Permit Number: 031015

has permission to decks on side instead of in rear of each deck parking also relocated (Amendment to #03-0116)

RE: 23-25 Cambridge St., corner of Cornell St. – 151A-A009 & part of 8 – R-5 zone
Permit application #03-1015

**AS BUILT PLAN OF A 2 STORY DUPLEX
AT 9 CORNELL STREET PORTLAND, MAINE**

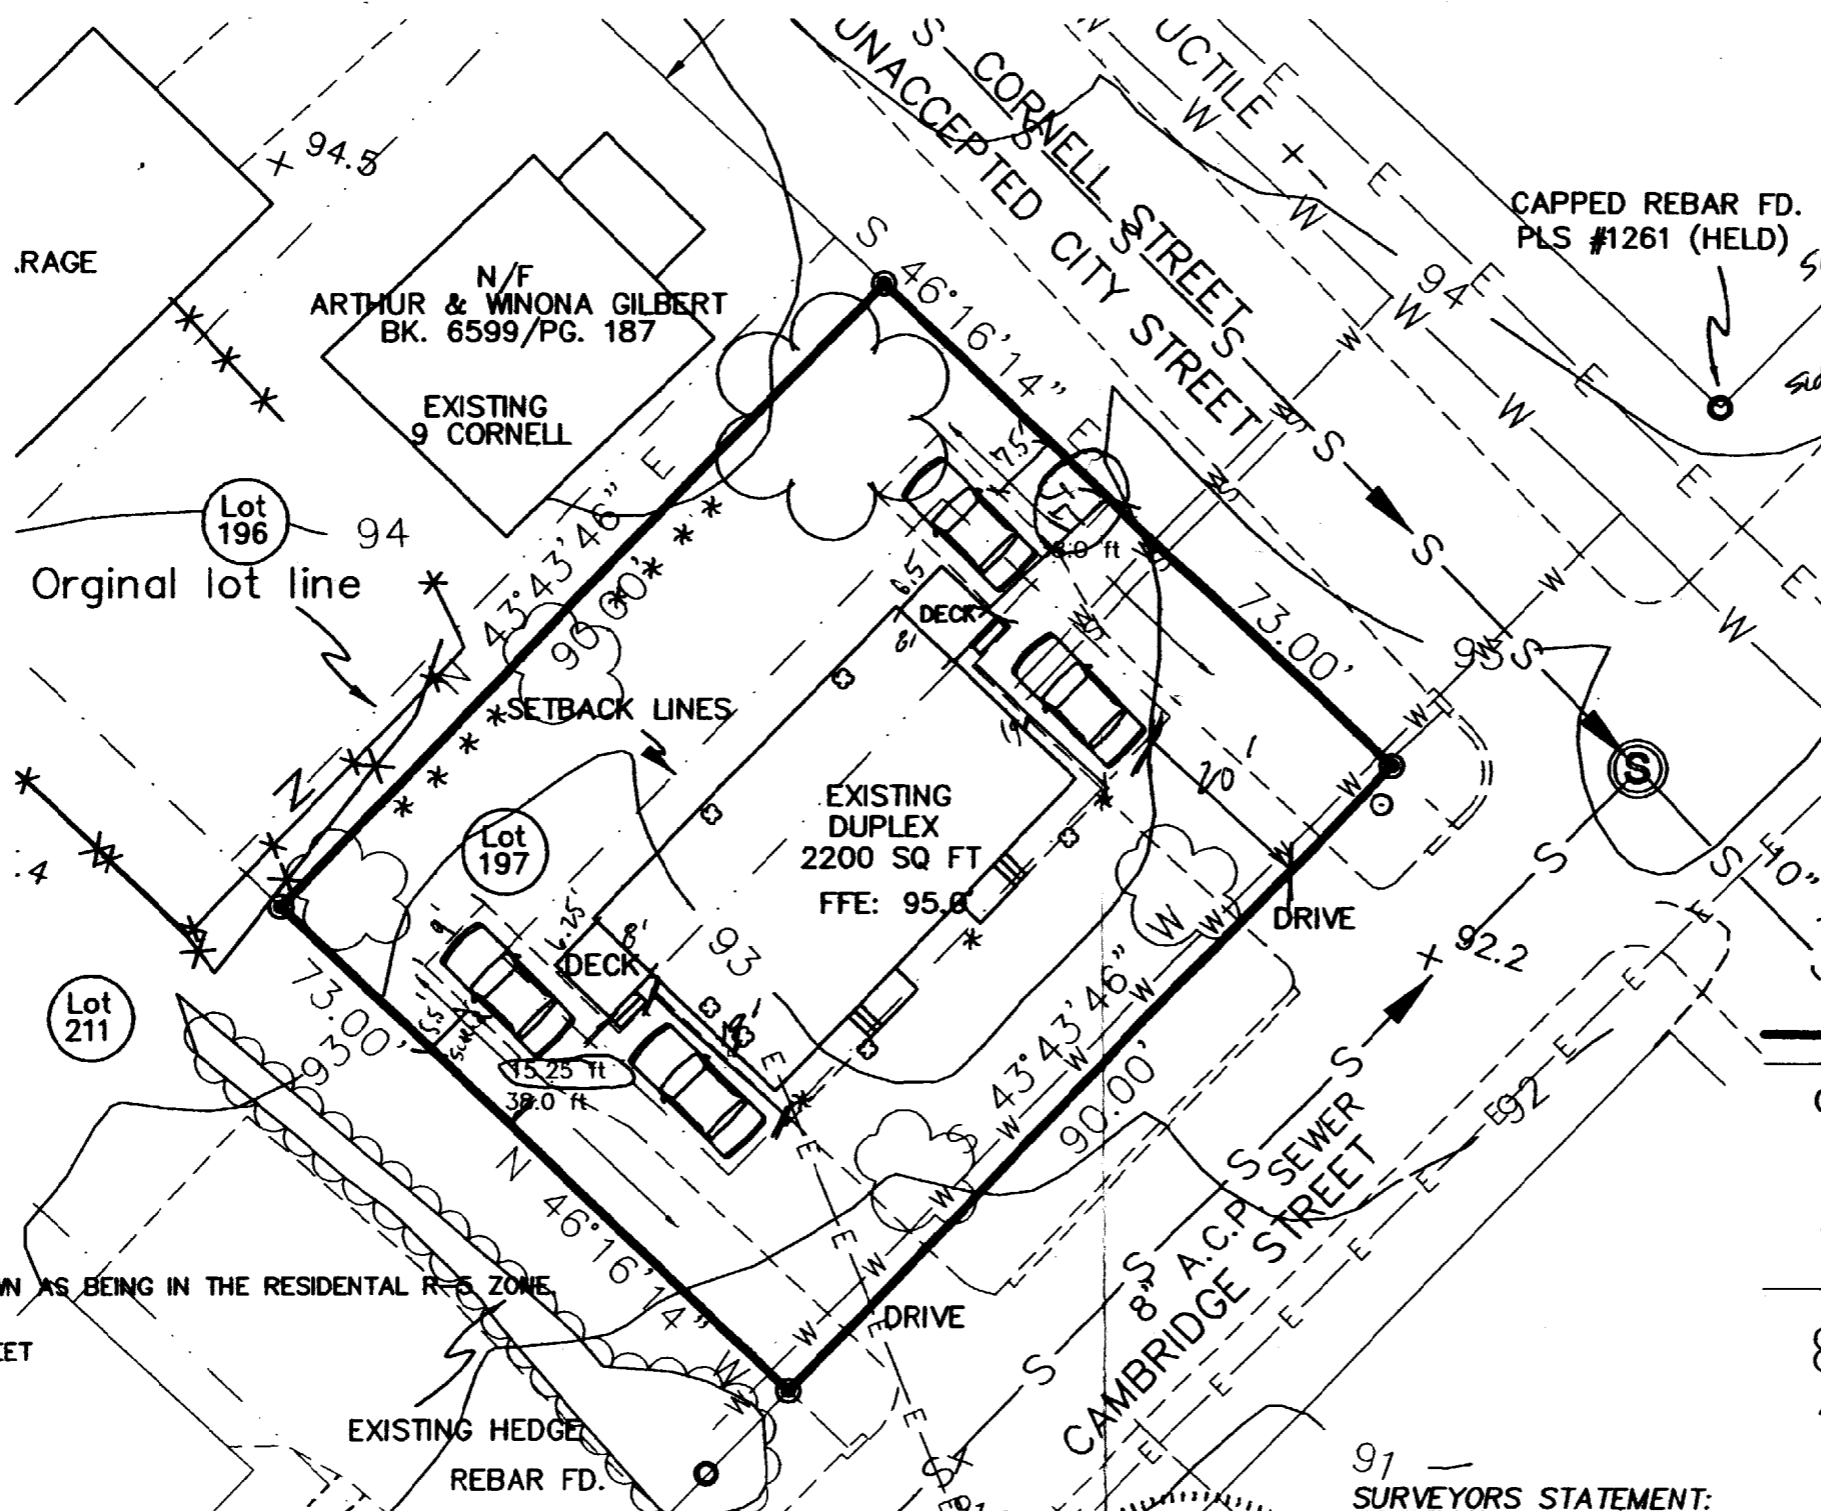
side yard on side st: 15' req
17' setback

side yard on other side: 12' req -
(2 story) 15.25' shown

2 parking spaces 9x19'
maintained

*final print
used for
review*

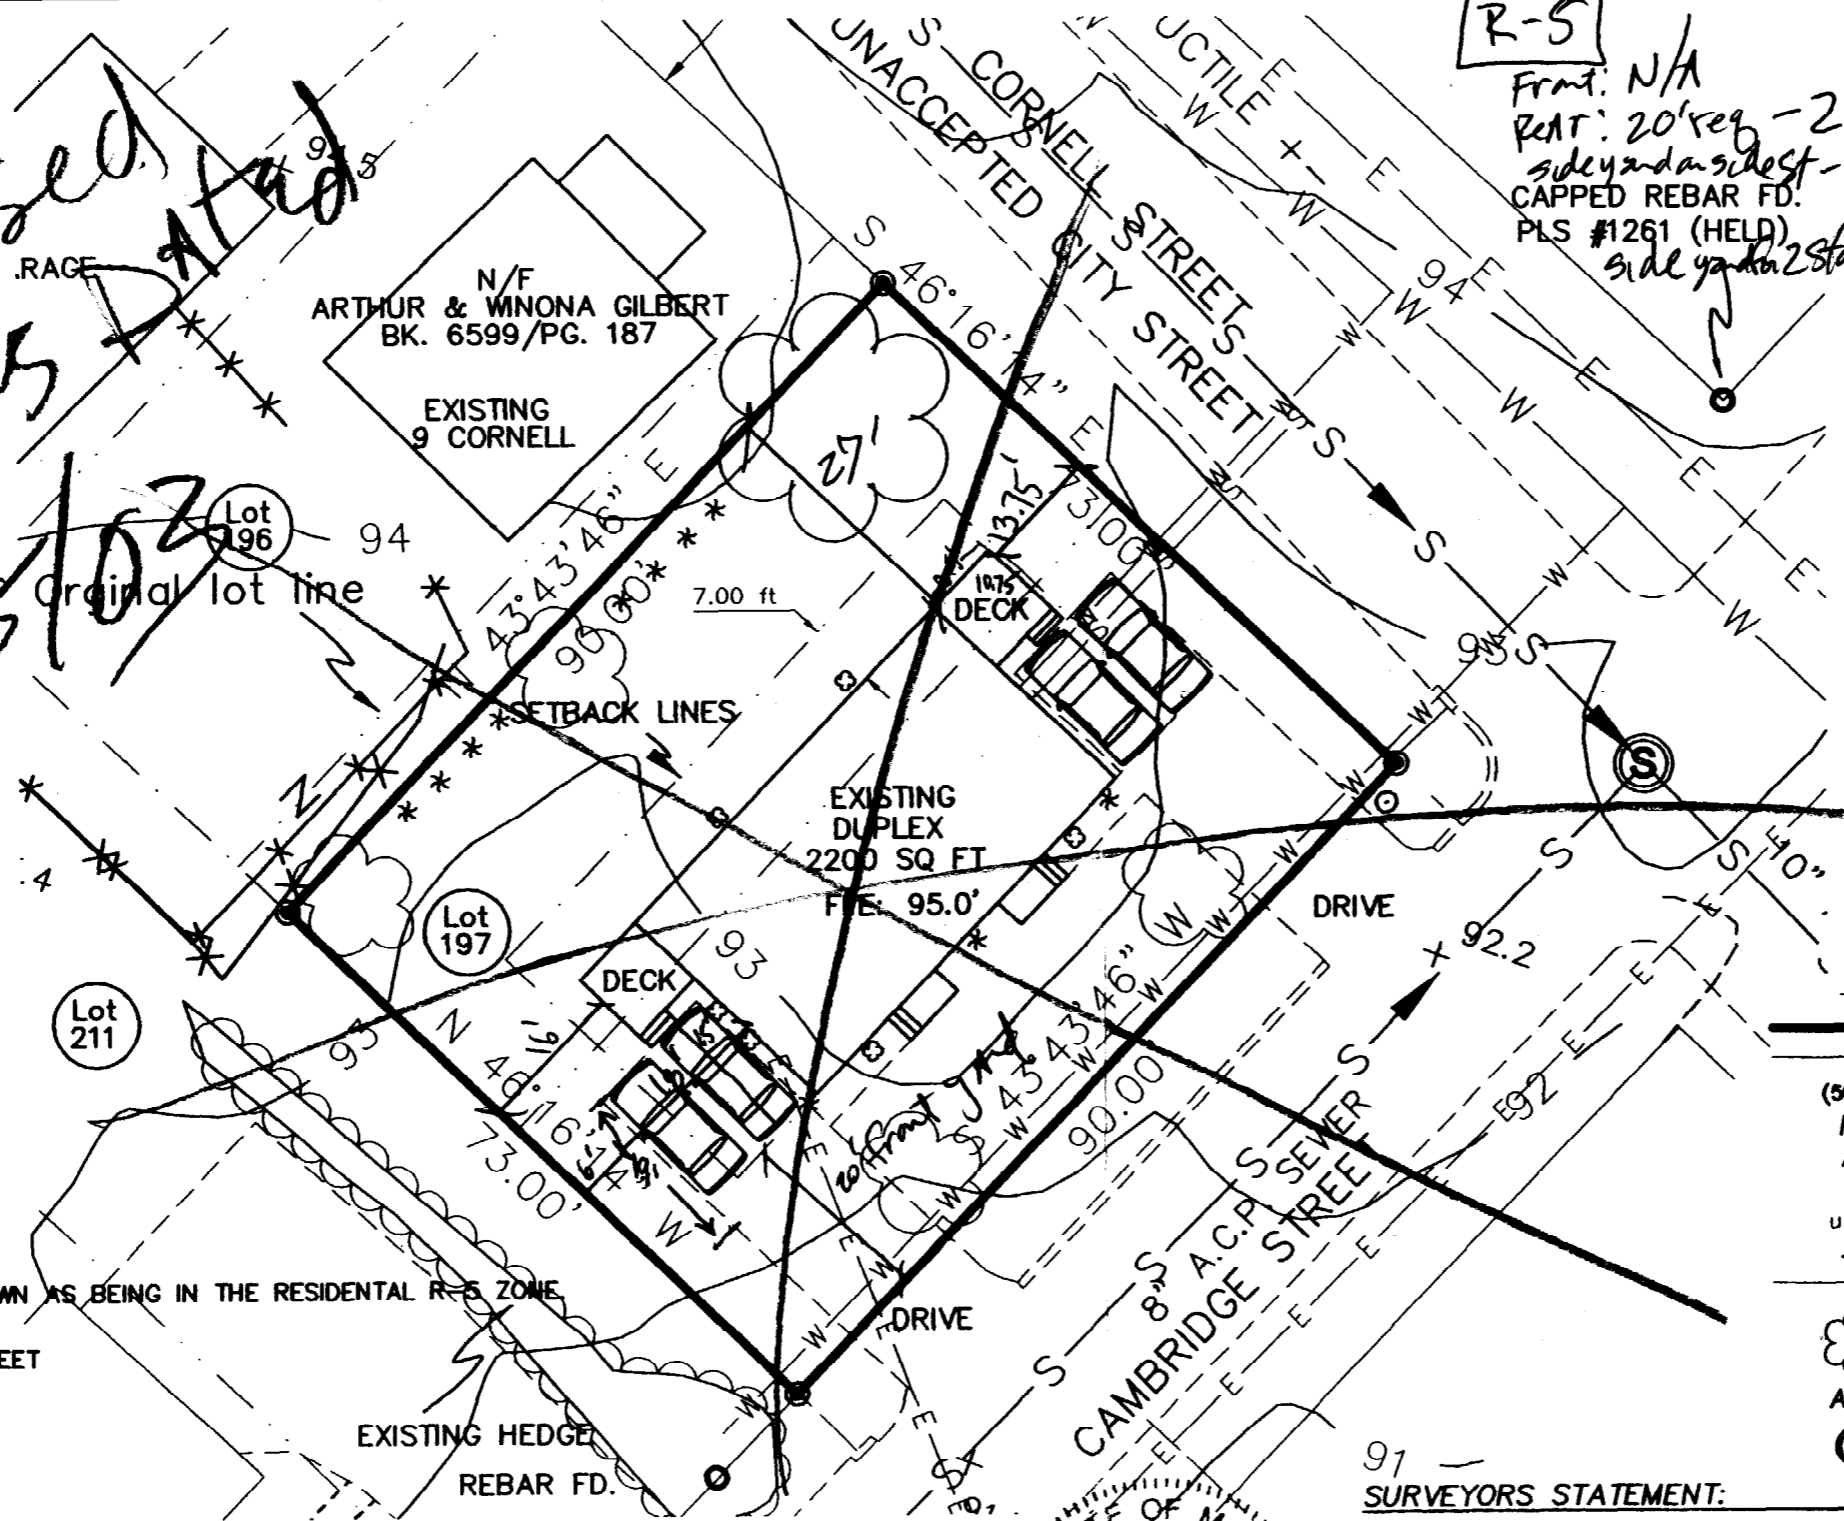
Section 14-120 requires a side yard setback on a side street (Cornell Street) to be a minimum of fifteen (15) feet. Your amended, submitted survey plans scale the setback at approximately 13.75 feet.

The plans have also changed the parking configuration for both dwelling units. A standard parking space size is 9' x 19' as required under the Technical and Design Standards and Guidelines as promulgated by the Planning and Public Works Departments. The parking spaces have been shown to be 7 ½ x 15 which is a compact car size. Compact space sizes are only to be used when providing over and above the required minimum number of spaces as designated by the Zoning Ordinance. You are providing the minimum number of parking spaces as required under the ordinance. If the correct 9' x 19' space size is shown on the plans, they would extend five (5) feet into the required front yard setback of twenty (20) feet. Section 14-336 prohibits required parking to be located within the required front yard setback when two driveways are provided on site.

see revised plans dated 9/25/02

R-5
 Front: N/A
 Rear: 20' req - 27' shown
 side yard on side street - 15' min - 13.75'
 CAPPED REBAR FD.
 PLS #1261 (HELD)
 side yard on 2 story - 12' req 16' shown

Applied for an Amendment 8/20/03
Plat spaces are 9x19' - 75' x 15' high

*See Revised
Plans Dated
8/25/03 which
corrects the deficiencies*
